DWG # V049-8-548
MGO-D961664-C-V

ITEM	QTY.	PART NO.	DESCRIPTION
PART LIST			MATERIAL SPECIFICATION 304 SST
UNLESS OTHERWISE SPECIFIED DIMENSIONS ARE IN INCHES TOLERANCES ARE:		CONTRACT OR SALES ORDER NO.	GNB Corporation SCIENTIFIC AND INDUSTRIAL EQUIPMENT 30971 San Benito Court HAYWARD, CALIFORNIA 94544 (510) 441-1900 FAX: (510) 441-0939
DECIMALS	ANGLES	FINISH	
.XX ± .01 ± 10'	12 1/2	12 1/2	
.XXX ± .005			
//, □, ⊥ WITHIN .05		APPROX. WT. 30#	
UNSPECIFIED FILLETS: R.015 BREAK EDGES .010 ± 45° REMOVE ALL BURRS		APPROVALS DATE	
THIRD ANGLE PROJECTION		DRAFTER	
		CHECKER	
C103303	DO NOT SCALE DRAWING	ENGINEER ZH	2-13-96
USED ON	CADD FILE NAME C103737C	TITLE TUBE, BEARING HOUSING G44E, G48E	
		SCALE: NONE	DWG. NO. 103737
		SHEET 1	OF 1
			REV. C

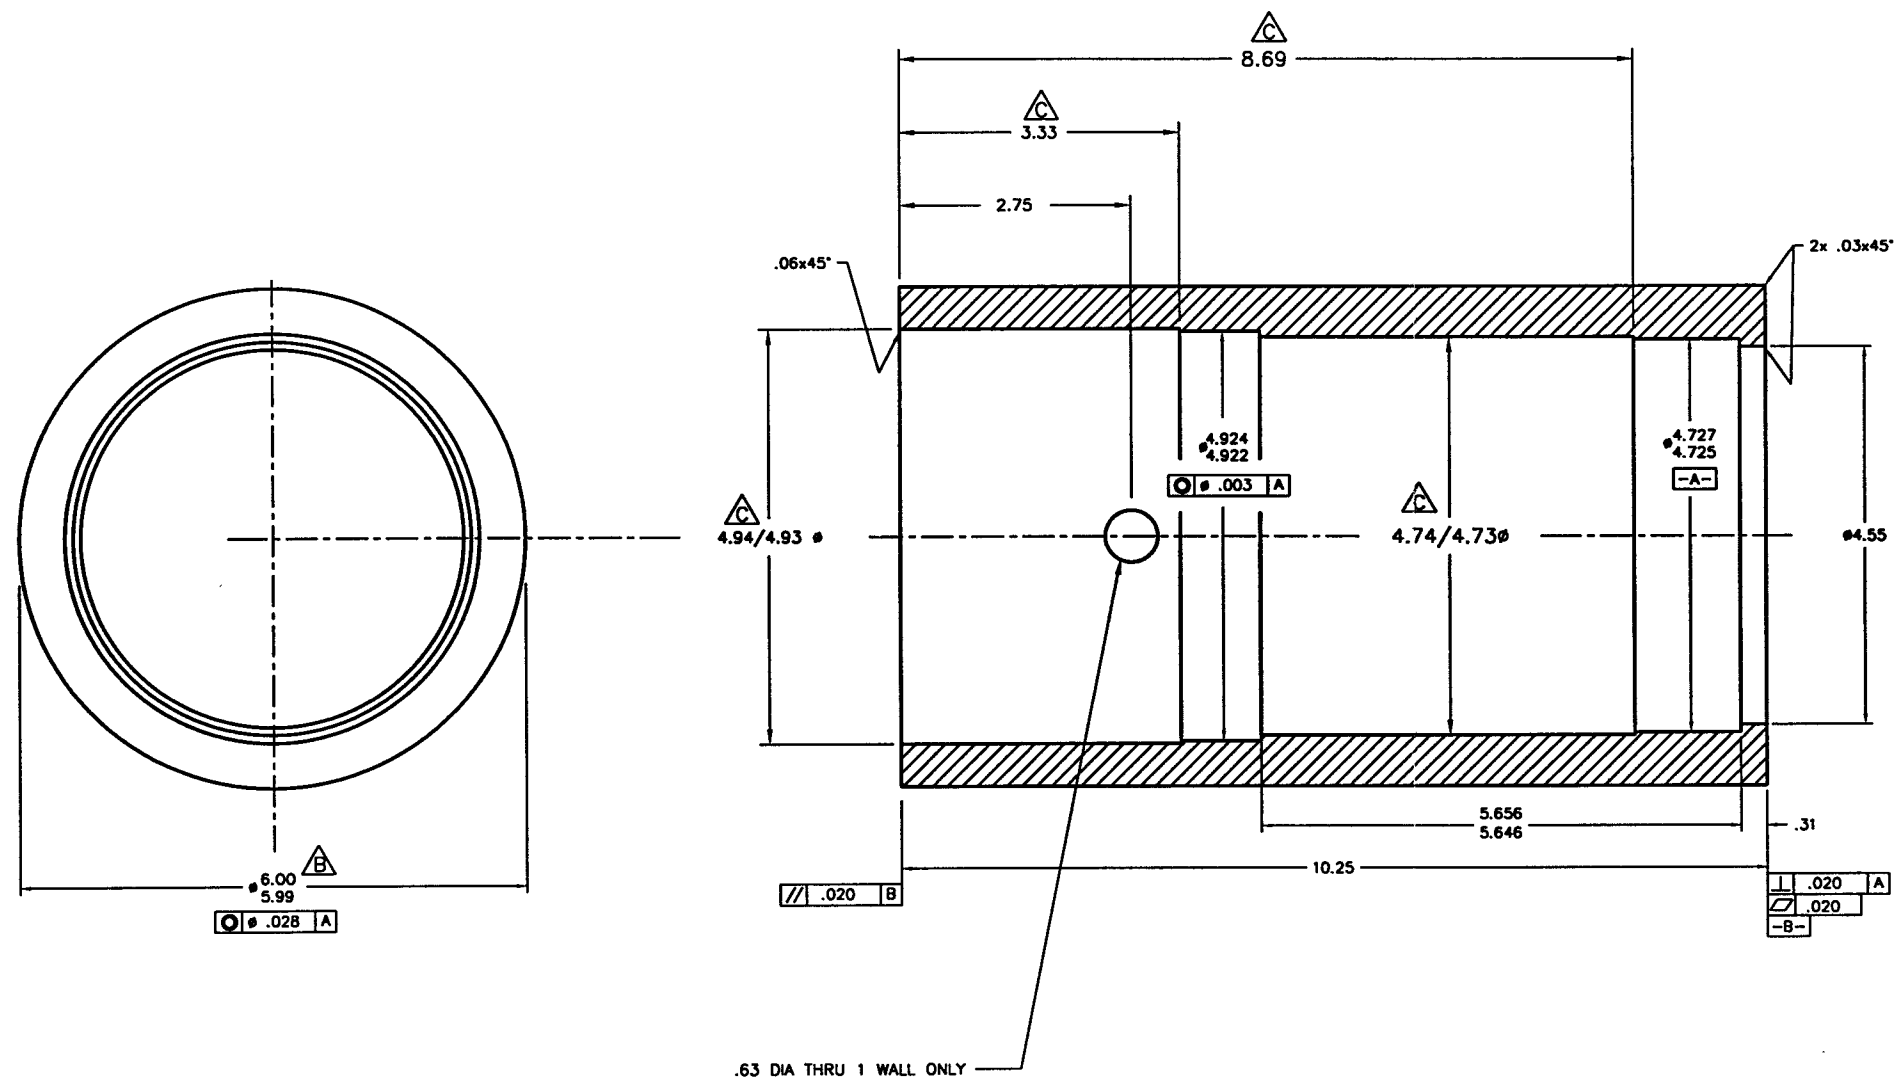
REV	DESCRIPTION	APPROVED	DATE
A	RELEASED		
B	CHANGED TITLE TO TUBE, BEARING HOUSING; DELETED GROOVE; 6.00/5.99 DIA WAS 6.00/5.94 DIA; DELETED ITEM #2. ADDED .63 DIA HOLE	A.J.L	9/7/96
C	ADDED C'BORES FOR EASE OF BEARING INSTALLATION	A.J.L	9/30/96
